Planning application 2017/1918/P

I wish to object to this application.

EXISTING & PROPOSED REAR ELEVATION 4.2

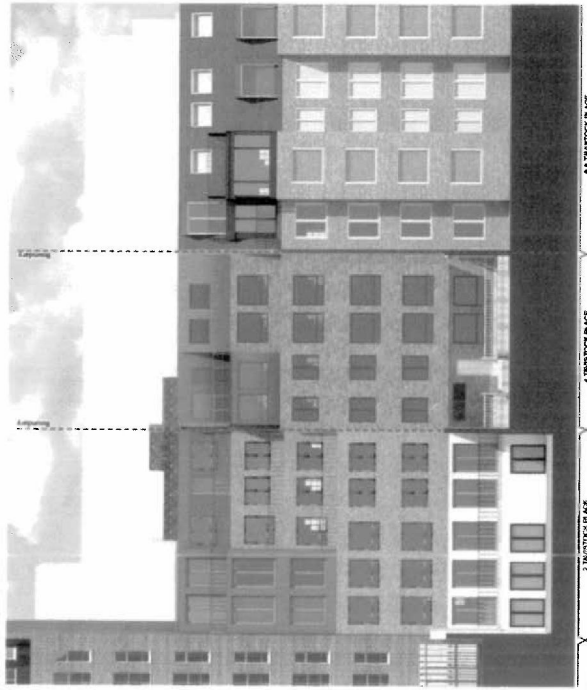
I live immediately to the east of the applicant, in a ground floor flat with a small garden. The plans for the application conceal this. Enclosure A is page 4.2 from part 2 of the Design and Access Statement. My flat is outlined. There is actually floor to ceiling window and a garden door immediately beside 4 Tavistock Place, not a small window. The door opens onto a small terrace and there are then steps down into the garden.

The present application changes this. The building would now extend into the garden at ground floor level alongside my garden. You can see this in enclosure A again and also in enclosure D, page 4.3 from the current Design and Access Statement. I have shaded blue the extra wall height beside my garden. The view from my flat is reduced and people will be able to look into my flat or garden from the extension

Back of
4 Tavistock
Place

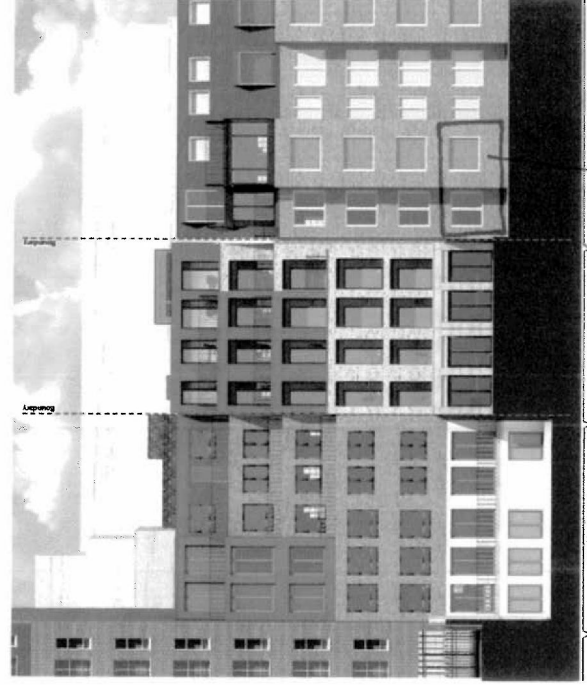
Enclosure B shows the view from inside this flat, through the window. There is quite a long vista to neighbouring trees and buildings, with very little of 4 Tavistock Place visible. I have outlined red where 4 Tavistock Place can currently be seen – hardly at all.

Extension below ground
approved in 2016, not visible
from 6 Tavistock Place

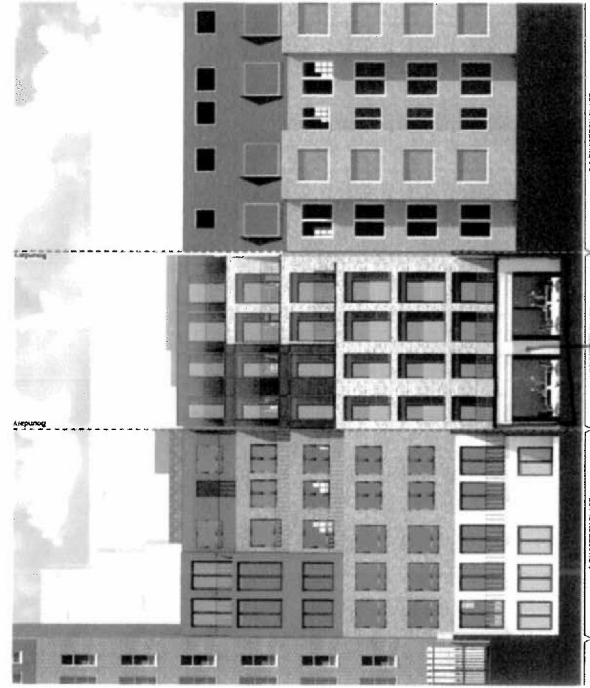
The 2016 application (granted) would not have changed this view much. The extension into the garden of 4 Tavistock Place was at basement level and largely out of sight of this flat. This can be seen in enclosure C, page 4.2 of the 2016 Design and Access Statement.

Isometric View |
As Proposed

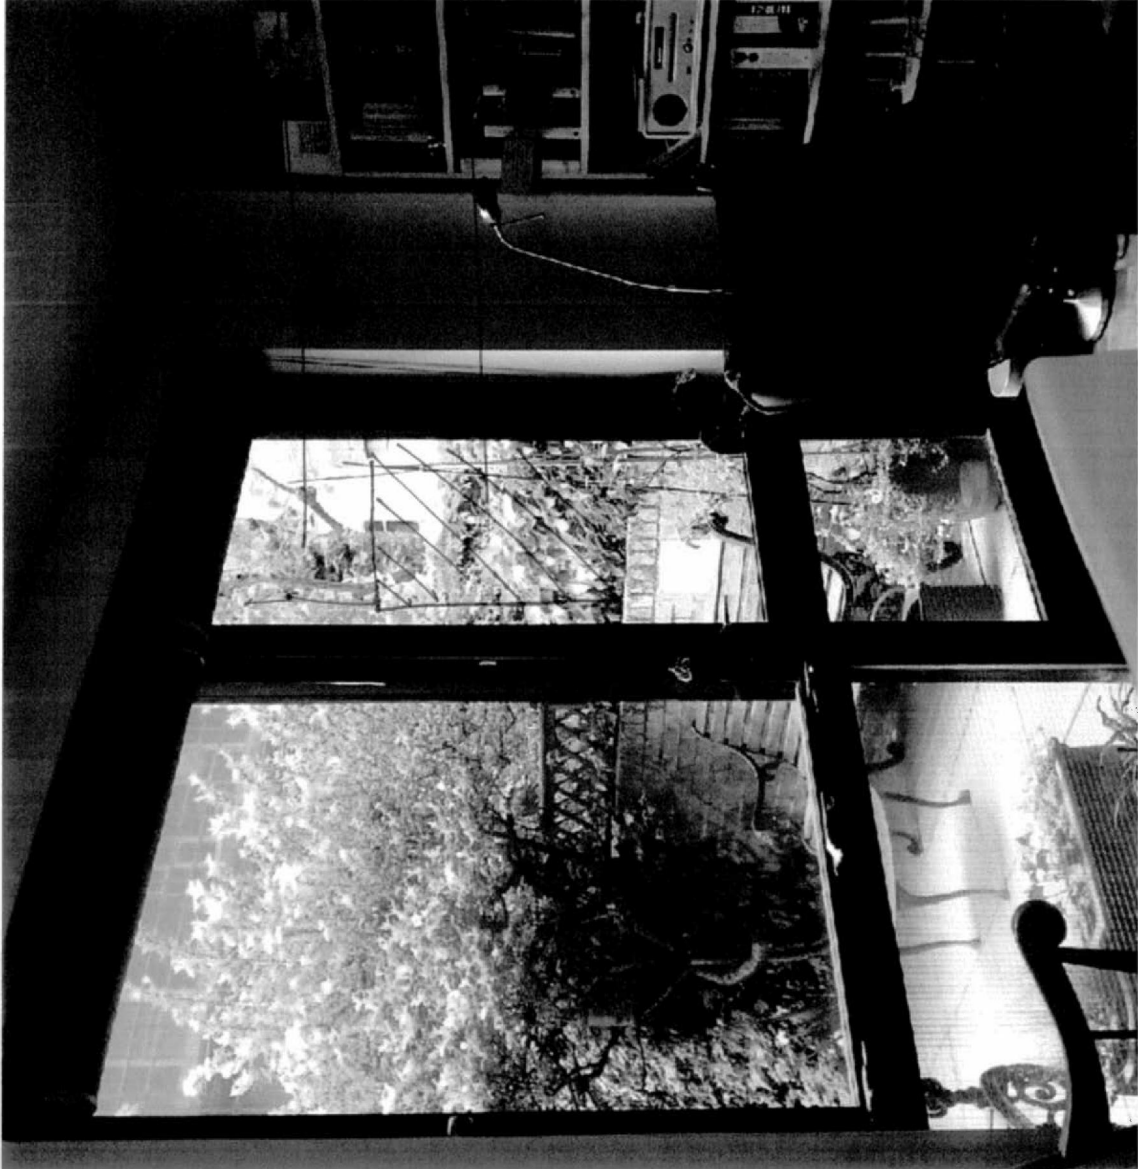
roof, a terrace. The terrace will also be close to a window in flat 7 Tamar House, directly above me. Enclosure E is enclosure B again with the extension sketched in. Enclosure F shows the extension from the garden.

additional wall beside garden st
6 Tavistock Place
